VIRGINIA ELECTRIC AND POWER COMPANY
RICHMOND, VIRGINIA 23209

AMENDMENT TO OPERATING LICENSES
SURRY POWER STATION UNIT NOS. 1 AND 2
PROPOSED TECHNICAL SPECIFICATION CHANGE NO. 74

PROPOSED TECHNICAL SPECIFICATION CHANGE 74

TS FIG 3.1-1

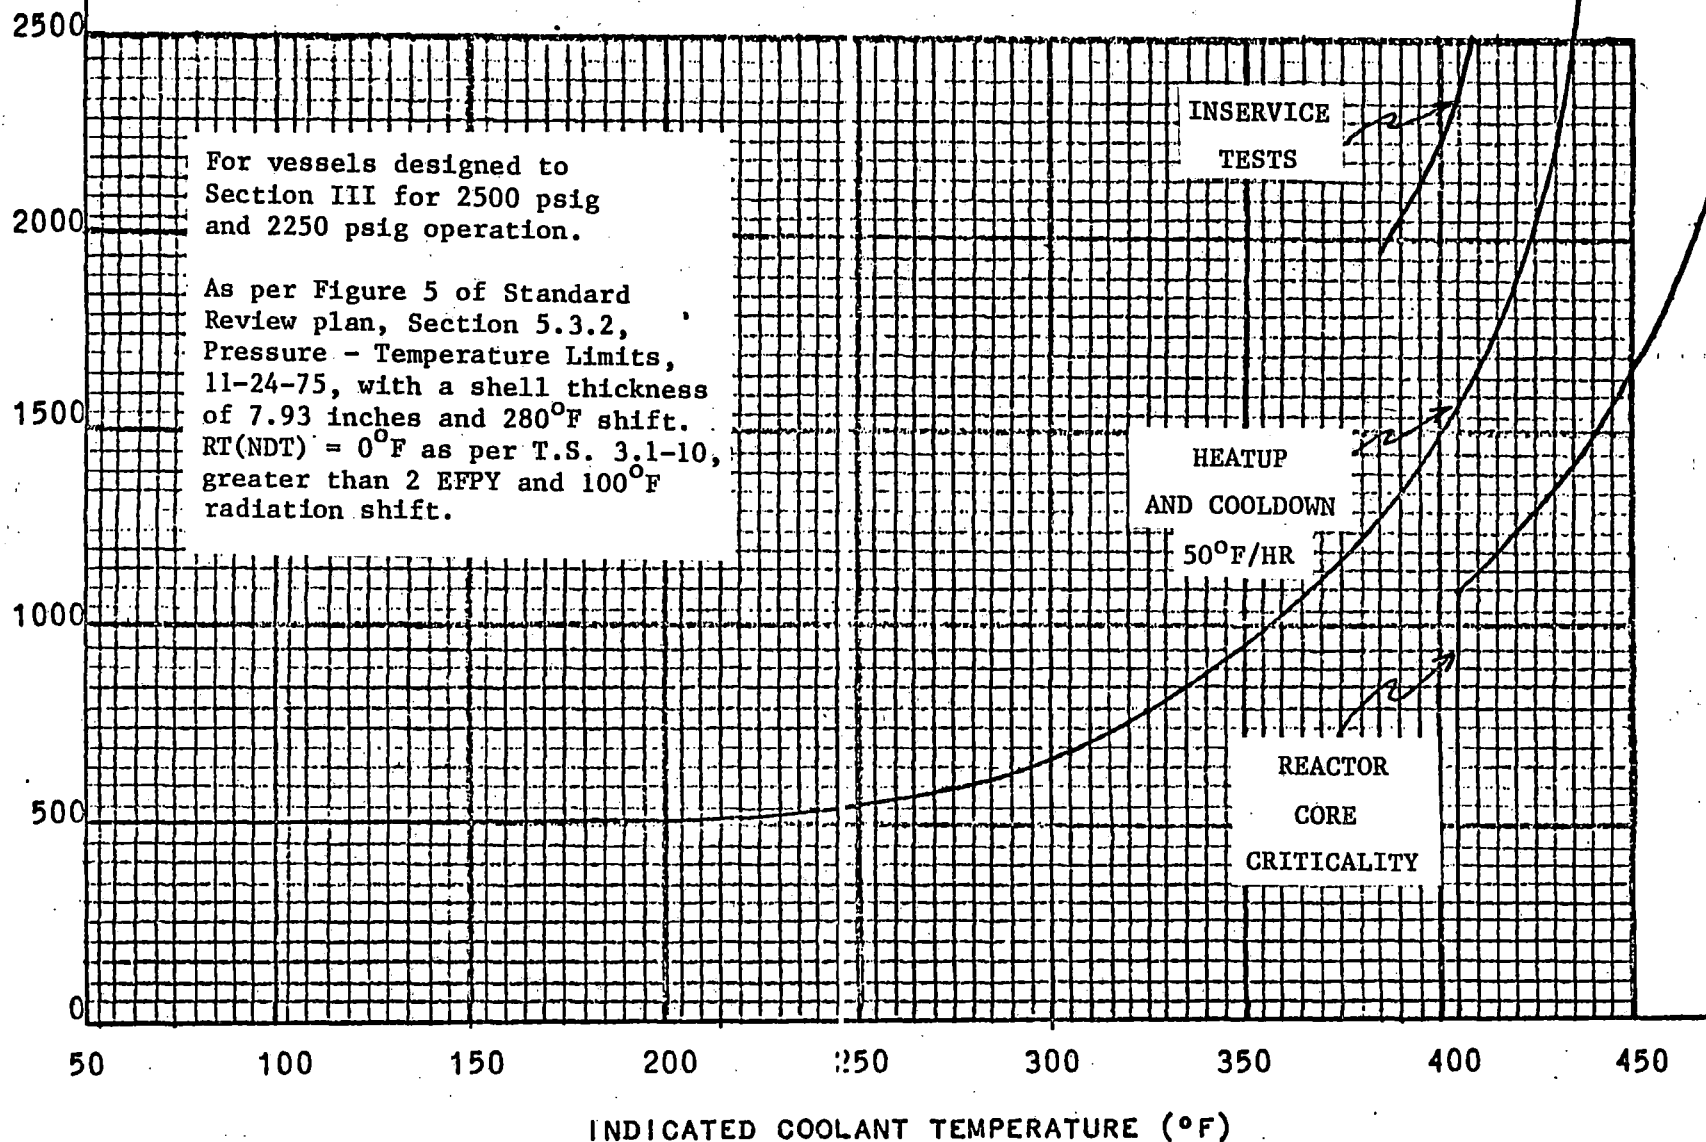
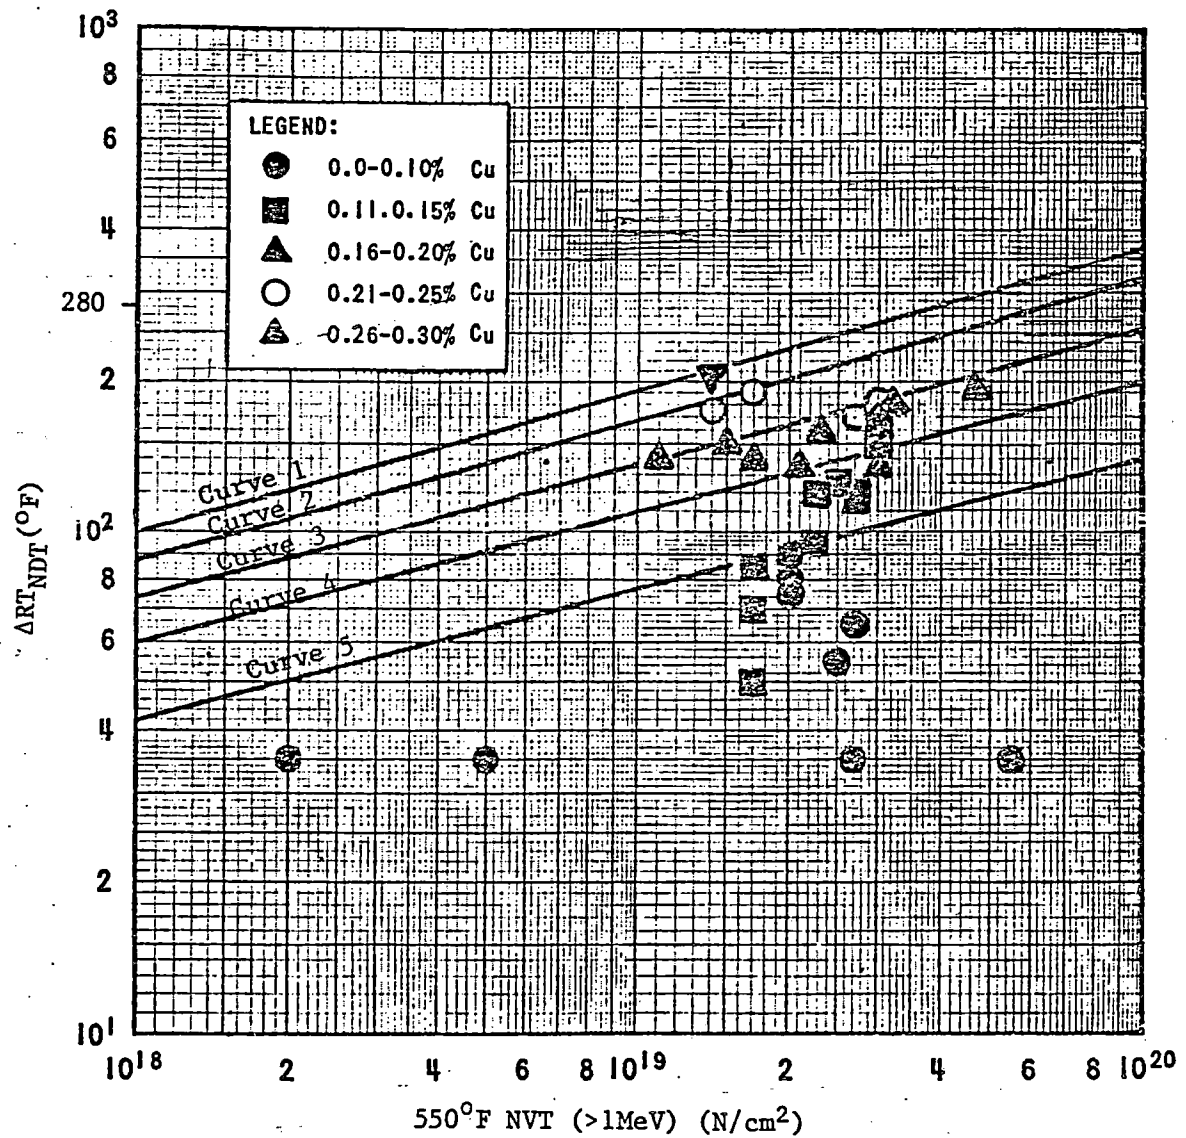
As discussed in Attachment 1, it has been demonstrated that the applicability of present TS Figure 3.1-1 can be extended to 32 EFPY. The revised figure is included in Attachment 2. Also included are revisions to Specification 3.1B which provide new procedures for updating Figure 3.1-1, if necessary, based on future fluence calculations on surveillance samples. Table 4.2-1 (Item 7.1) has been revised to specify dosimetry as the examination method for reactor vessel irradiation surveillance.

Due to the previous 280°F shift, the present T.S. Figures 3.1-1 is calculated to be valid beyond 32 EFPY. T.S. Figure 3.1-3 will be added to show the relationship between operating time and fluence at the 1/4 thickness of the vessel as described in the FSAR, Section 4. As the note on T.S. 3.1-3 infers, the slope of this curve was established from a 280°F shift for 32 EFPY and is more conservative than any existing data.

FIGURE VALID UP TO 32 EFPY.

Figure 3.1-2. Radiation Induced Increase In Transition Temperature

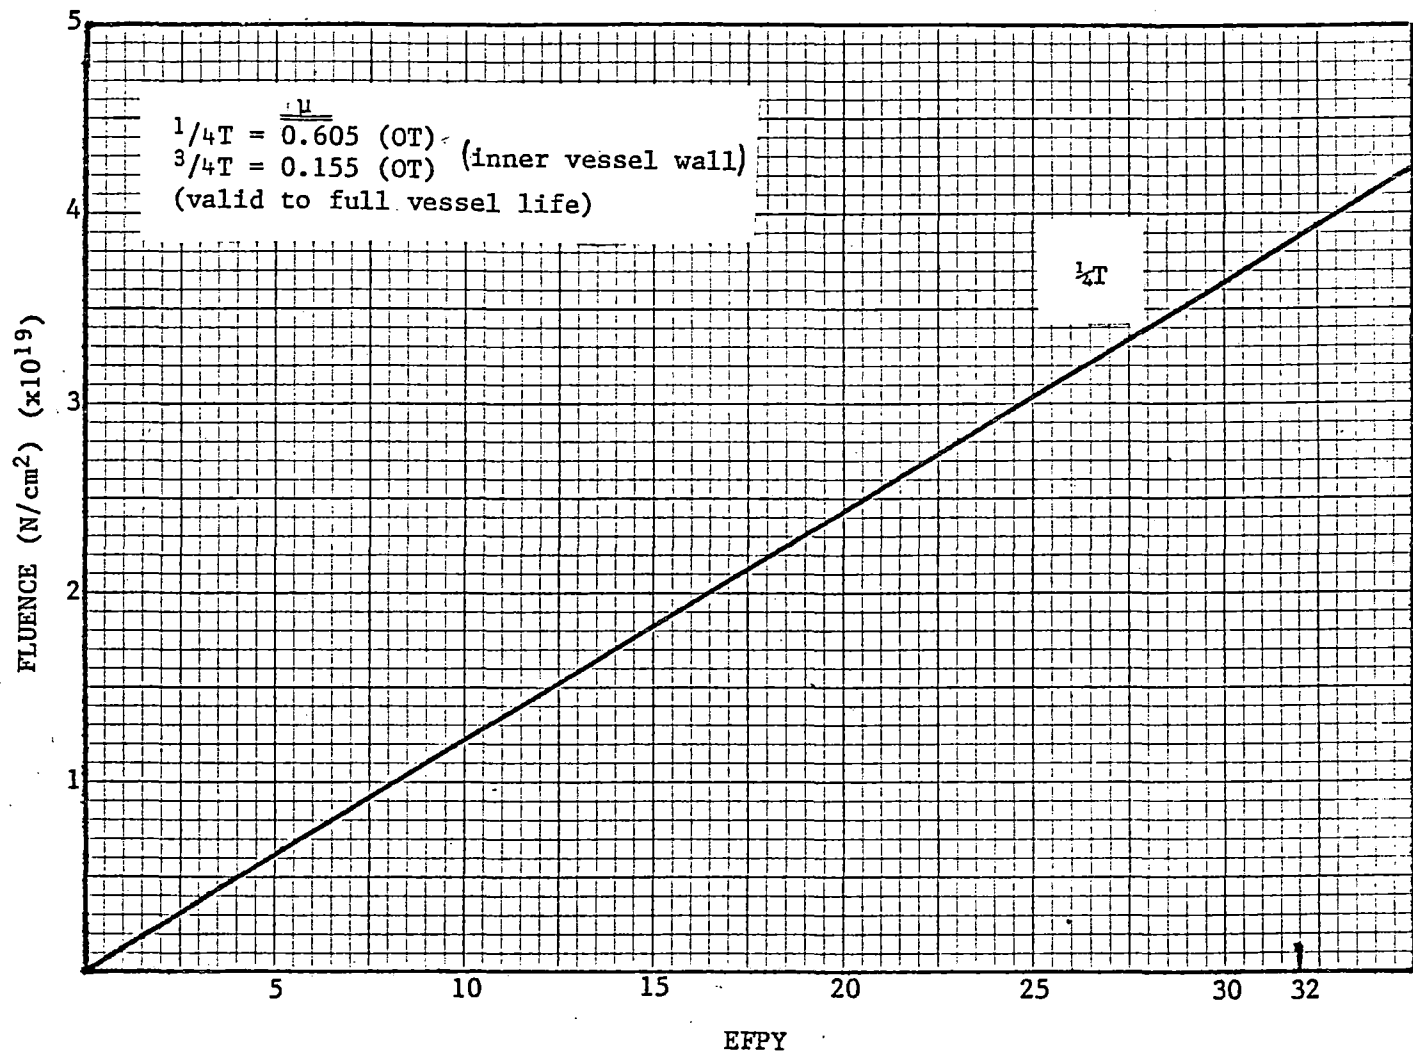
T.S. Figure 3.1-2 will be modified to omit Curve 1 since it is based on nonrepresentative material. The original ΔRT_{NDT} versus fluence T.S. Curves will be used. The individual curves will show base metal and weld metal copper content.

Curve 1 - 0.30% Cu base, 0.25% Cu weld
 Curve 2 - 0.25% Cu base, 0.20% Cu weld
 Curve 3 - 0.20% Cu base, 0.15% Cu weld
 Curve 4 - 0.15% Cu base, 0.10% Cu weld
 Curve 5 - 0.10% Cu base, 0.05% Cu weld
